Jesse Davis - Comments: major use permit application # U_2020-0002 by Brutocao Vineyards & Getaway House

RE: Case # U_2020-0002, Notice of an Initial Study for the Proposed Major Use Permit:
Getaway House, Hopland, CA

**Subject: Brutacao Vineyards' Gateway House, State Clearinghouse
 Number 2020040111**

Figure 2, Preliminary Site Design, reproduced below, shows the areas of proposed development (please note the irregularities in the figure below, which make it very difficult to read, are directly from the environmental documentation).

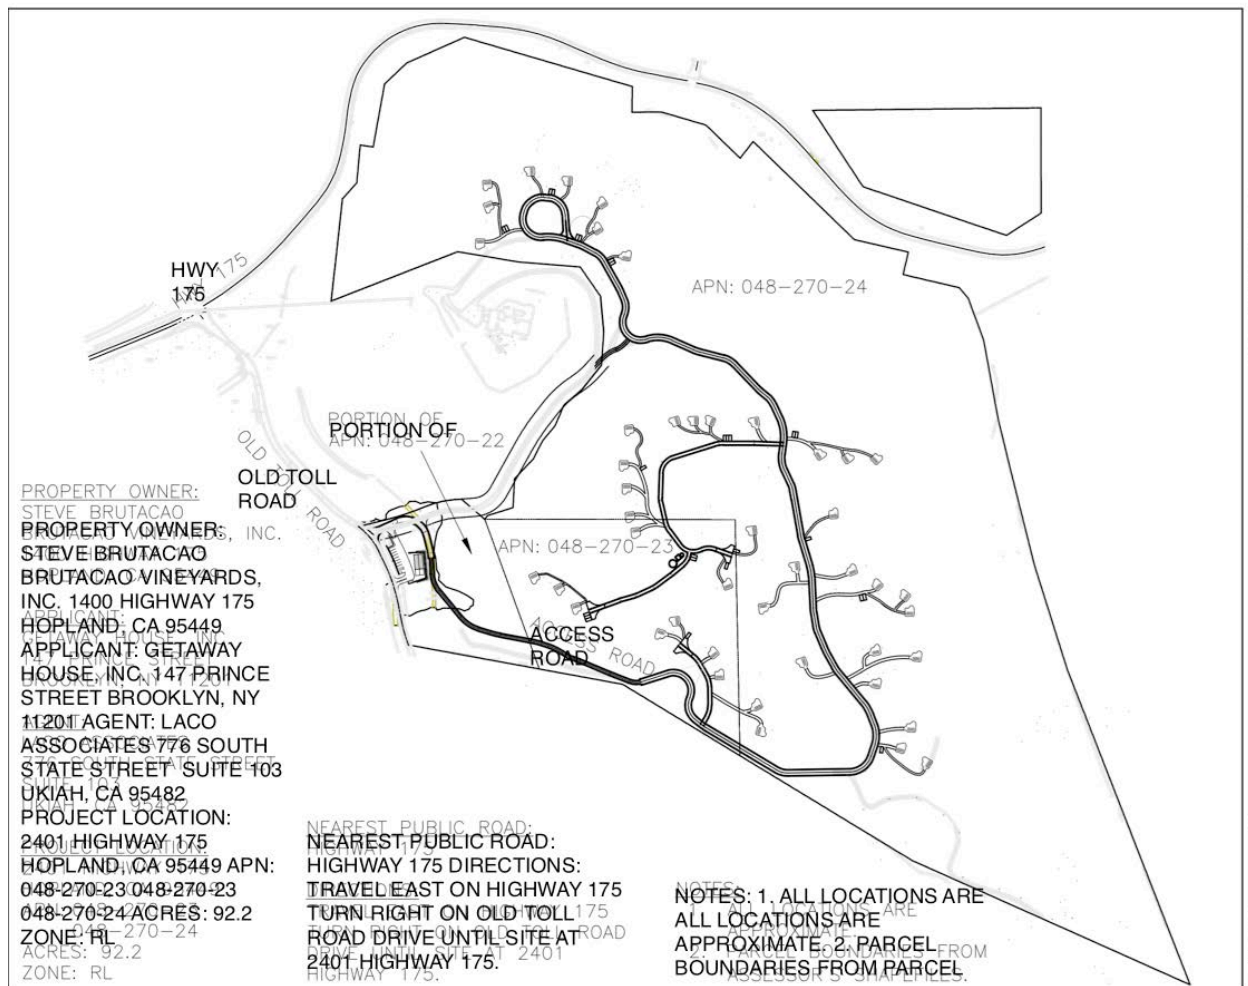
Discussion: The Draft Initial Study does not adequately assess project impacts to the site's oak woodlands. Instead it simply lists oak species on the site and provides a figure of 5.49, which appears to be erroneous, as an estimate of the total area that will be disturbed:

Comparing that map (as well as the map in Appendix B) and the Subject Parcel(s) map, it appears that the figure of 5.49 acres of impact is incorrect, as is the estimate of 6.05 percent. While it may be correct that road construction and widening activities will remove approximately 6.05 percent of the site's natural area, the preliminary site design map shows a much larger area that is fragmented.
